# ORIGINATION FORM •

## Proposed Revisions to a Standard Plans Index

Index Number: 641-020 Sheet Number (s): All Index Title: Concrete CCTV Pole

LAST REVISION 11/01/21

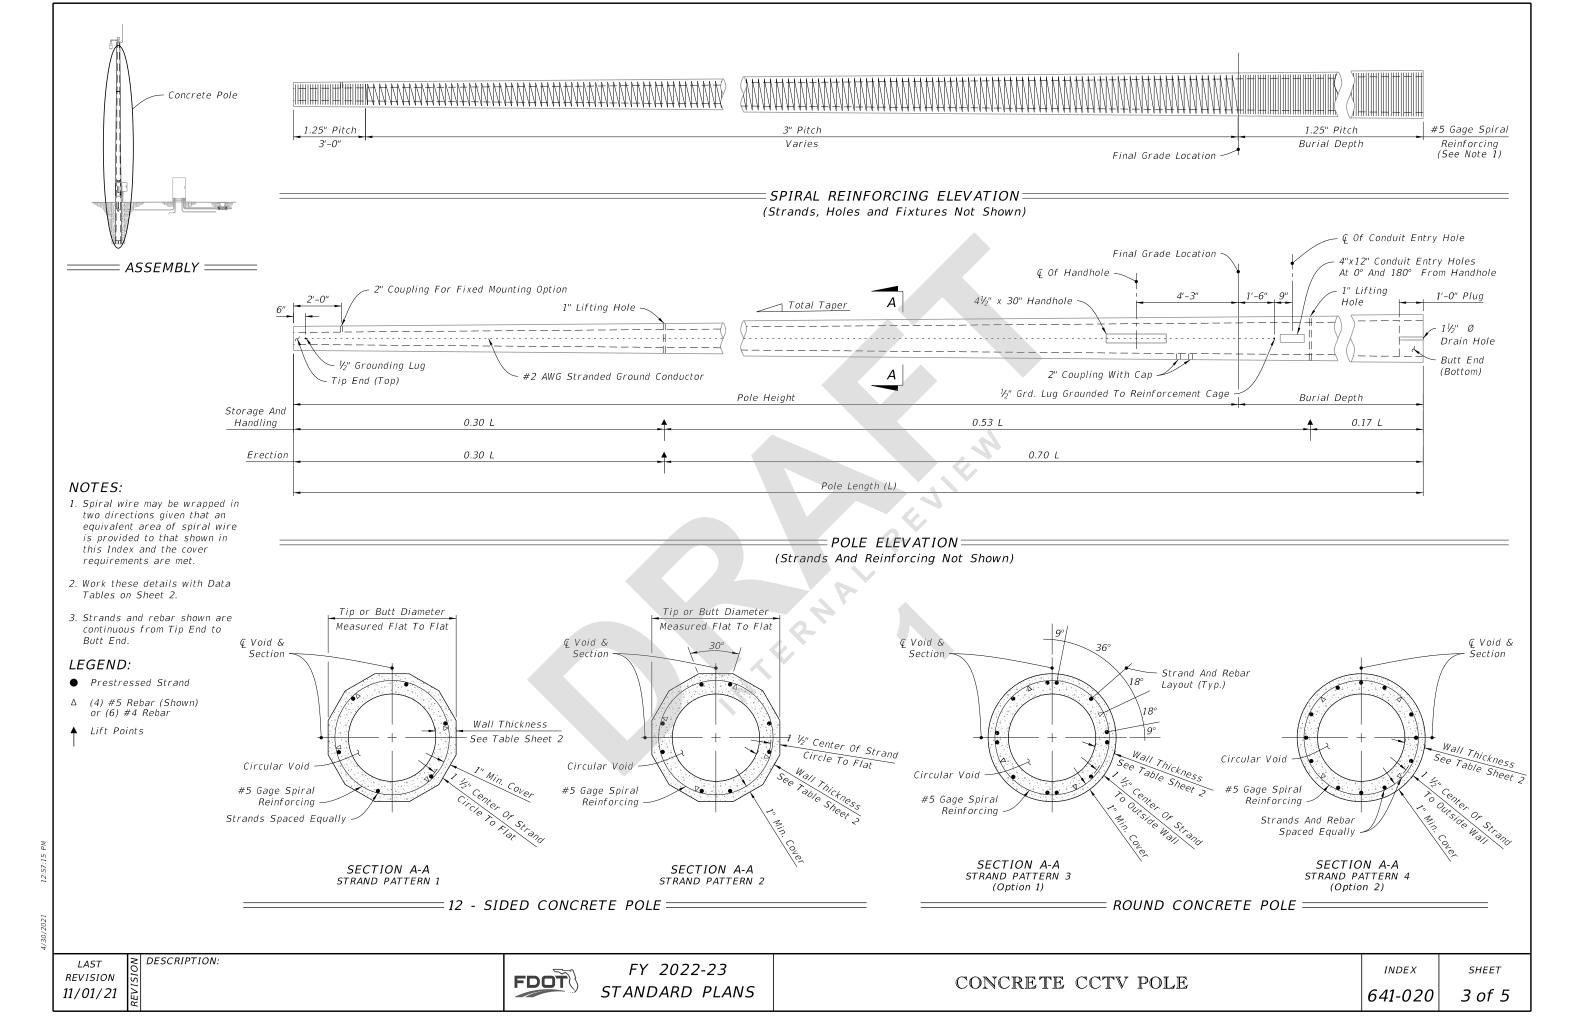
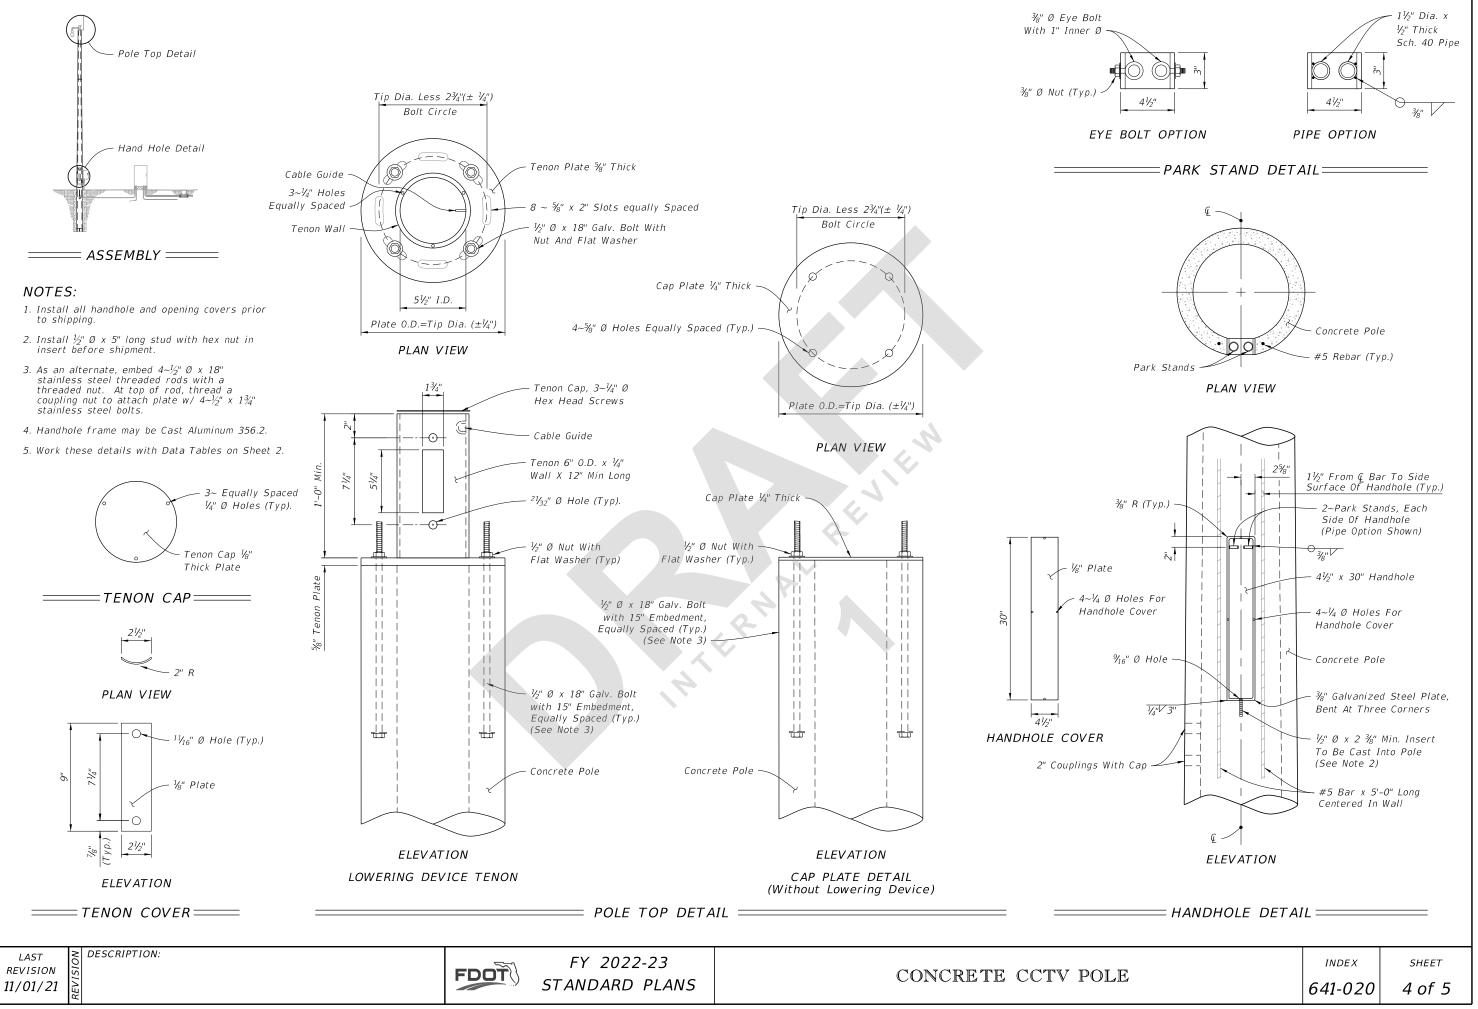
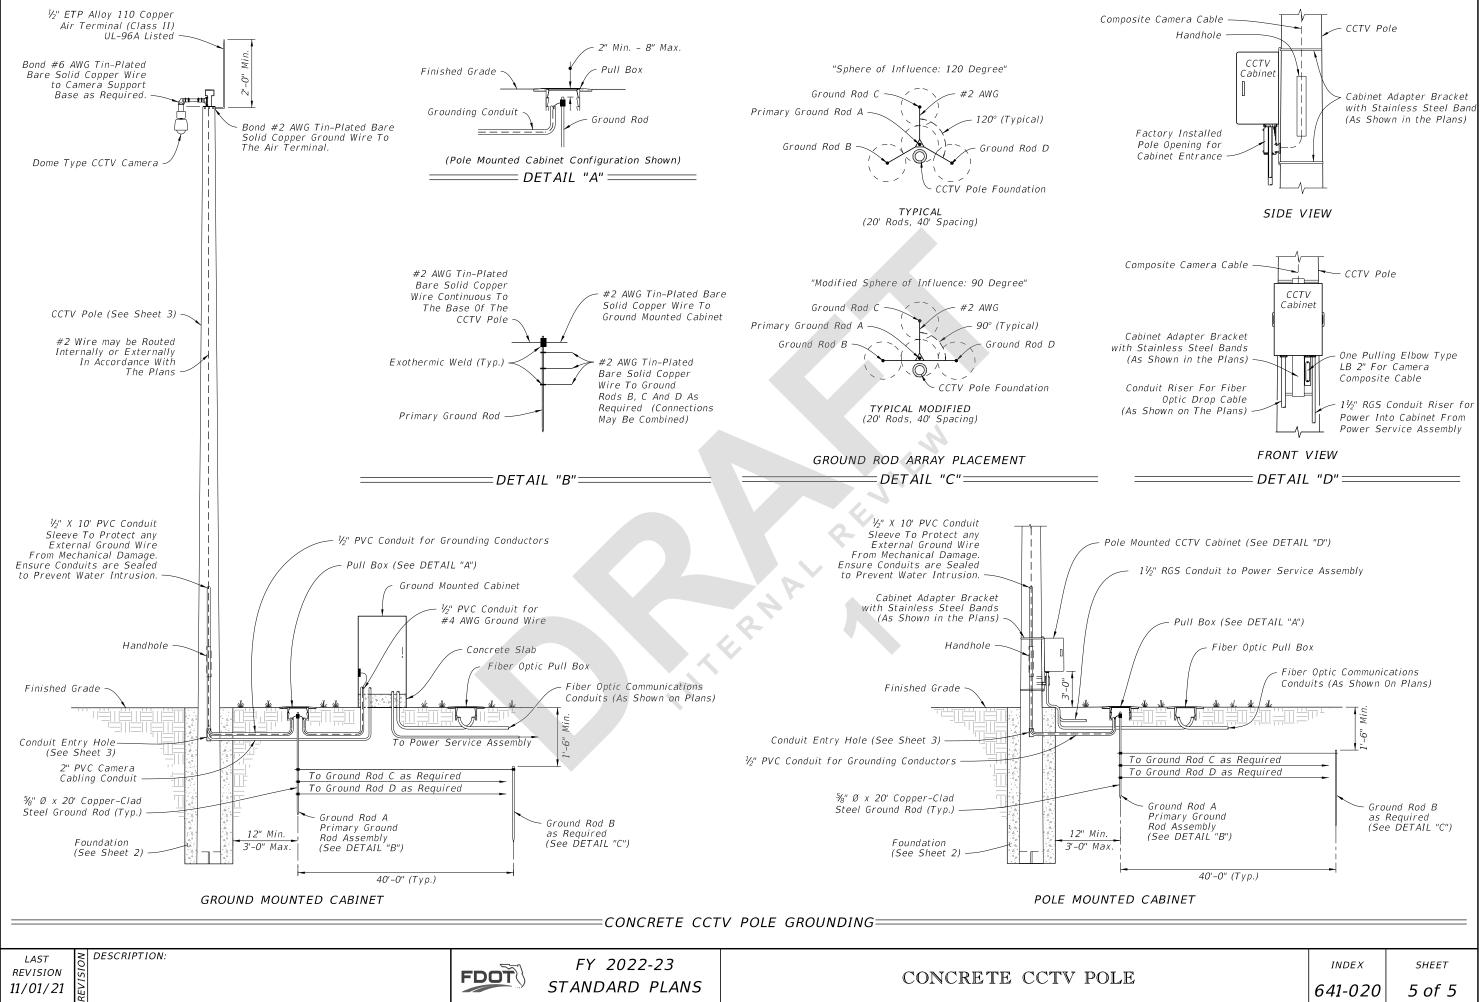
Sheet 1: Move Note 3 to new Note 7; Added Note 7; Renumbered General Notes; Dashed the Identification Tag and the handhole in the CCTV POLE ASSEMBLY detail.

Sheet 2: Updated the Assembly detail to match Sheet 1; Realigned the PLAN VIEW detail to match the Pole direction;

Dashed the Identification Tag and the Handhole in the ELEVATION detail.

Sheet 3: Updated the Assembly detail to match Sheet 1; Moved the Spiral wire note in the SPIRAL REINFORCING ELEVATION detail to the Notes and added See Note 1 to the Spiral Reinforcing call out; Dashed the Conduit Entry Holes in the POLE ELEVATION detail to be consent with the Pole's view.

Sheet 4: Updated the Assembly detail to match Sheet 1; Added Note 5.

Sheet 5: Added Handhole to the CONCRETE CCTV POLE GROUNDING detail and to DETAIL "D"-SIDE VIEW detail.

The location of the couplings shown on the CCTV Pole Assembly on sheets 1 and 2 do not correlate with the location of the couplings shown on the Pole Elevation and Handhole Detail shown on sheets 3 and 4. The handhole should be located downstream of the traffic so all details and notes will be updated for the proper representation.
